George Brown College (GBC)  
160 Kendal Ave  
Toronto, ON M5R 1M3

Addendum Number	One (1)
Addendum Date of Issue	Friday, January 17, 2025.
RFP Number	FM-2024-038
RFP Description	Casa Loma Campus – Buildings C & E Roof Replacement
Page(s)	Seven (7)
Number of Attachment(s)	One (1)

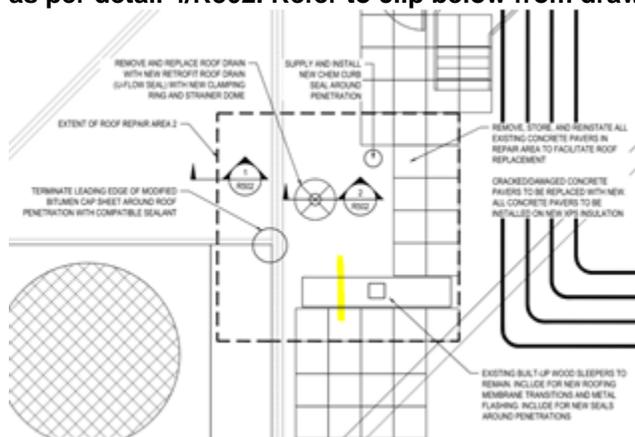
21. Please clarify the location of detail 4/R502 as it is not noted on any plan drawing.

**Answer: A built-up wood curb exists within extent of work in repair area 2 which is to be re-flashed as per detail 4/R502. Refer to clip below from drawing package.**
